Product Change Notice (PCN)

PCN Number: **PCN-0451091R-01**

Product(s) Affected: **PJ-043-SMT-TR**

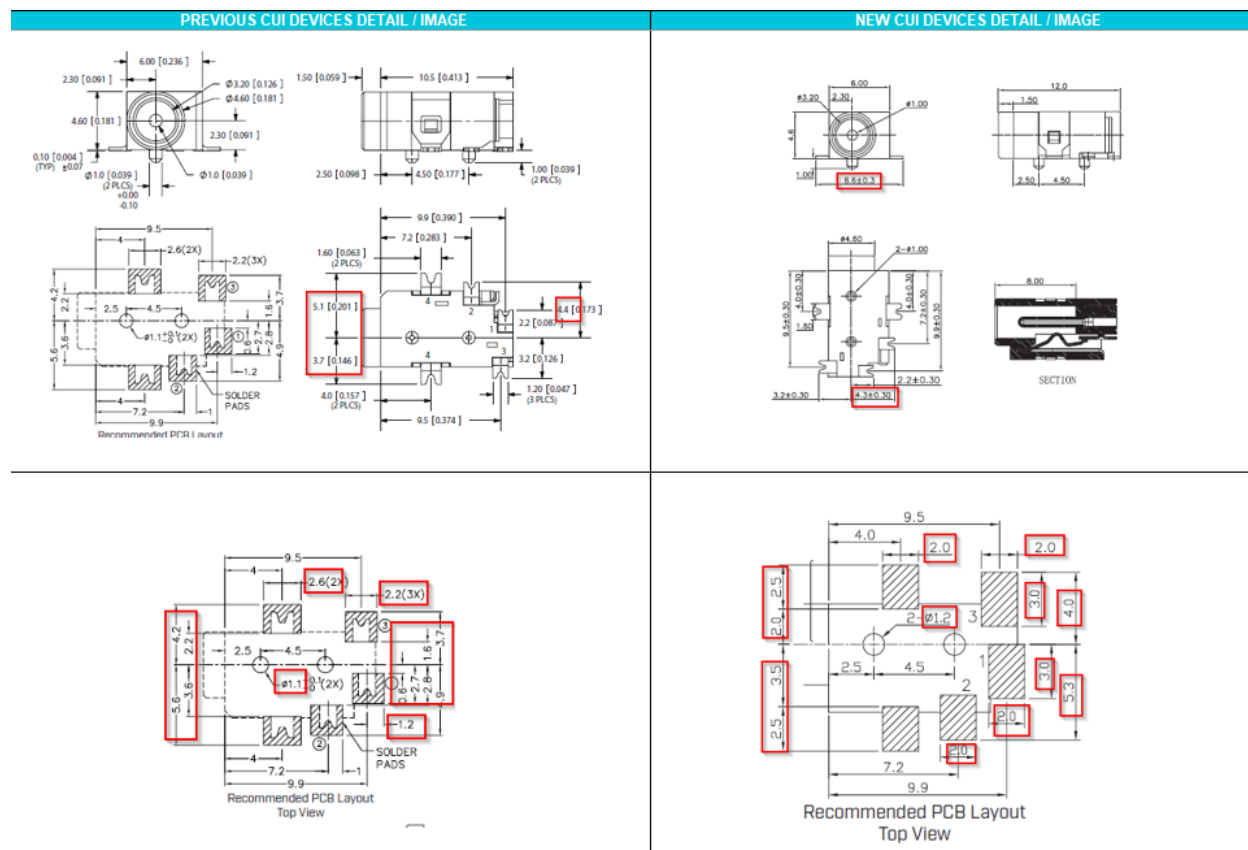
Description of Change: **Minor Housing and footprint differences. Material Change on the housing and terminals. See image Below**

PREVIOUS CUI DEVICES DETAIL / IMAGE			NEW CUI DEVICES DETAIL / IMAGE		
	MATERIAL	PLATING	DESCRIPTION	MATERIAL	PLATING/COLOR
center pin	brass	silver	center pin	brass	tin
terminal 1	brass	silver	terminal 1	brass t-0.25	tin
terminal 2	copper alloy	silver	terminal 2	SUS301 t-0.25	tin
terminal 3	brass	silver	terminal 3	brass t-0.25	tin
shield	cold rolled steel	nickel	shield	brass t-0.25	tin
plastic	PA6T or equivalent		housing	PA9T (UL94V-0)	black
